SKEP III Home Office Support Site Visit Report

Consultant	Wahib Medanat Consultant Engineer	Rep No.	21-21092021
Contractor	Dijlah Establishment Constr. Contracting	Tender No.	(11/2019/USAID/SKEP/3/S) Schools for a Knowledge Economy Project (SKEP) - Phase (3) Package (1, 2)
Site Name	Hay Al Iskan Basic Mixed School- Jerash	Day/ Date	Tue. 21/09/2021
Duration of Project	450 Calendar Days	Total Project Budget	8,314,983.735 JD

(Figure: 03 & 04)

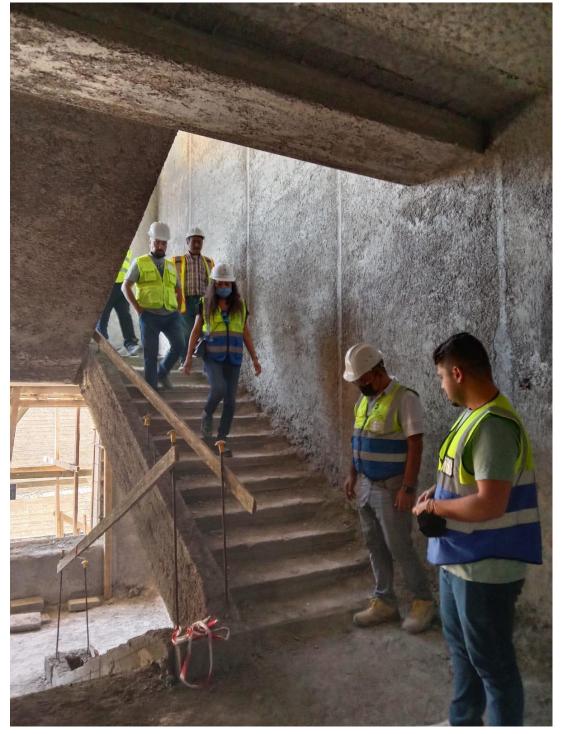
A number of mechanical cabinets in the sanitary units are close to the door frames incompliance with the shop drawings.

The Contractor was requested to remove those cabinets to allow for tiling around in an appropriate way

(Figure: 10)

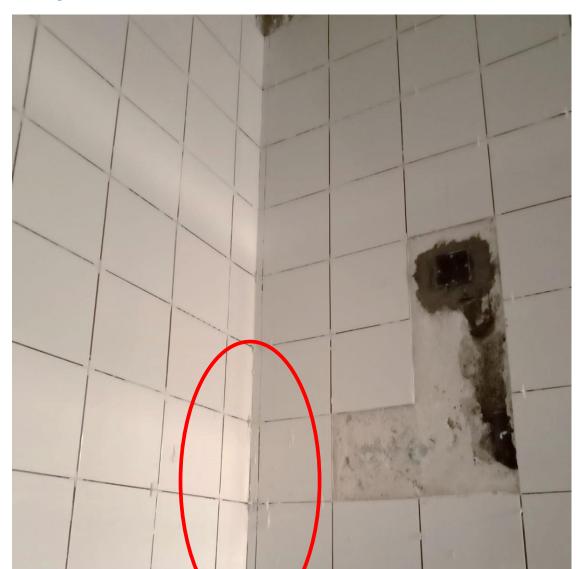
The supervision team observed that the tiling work at one wall does not comply with the shop drawings due to defect in the starting points of tiling

The Contractor was requested to remove the installed tiles at that wall and reinstall in coordination with the supervision engineer as per the approved shop drawings
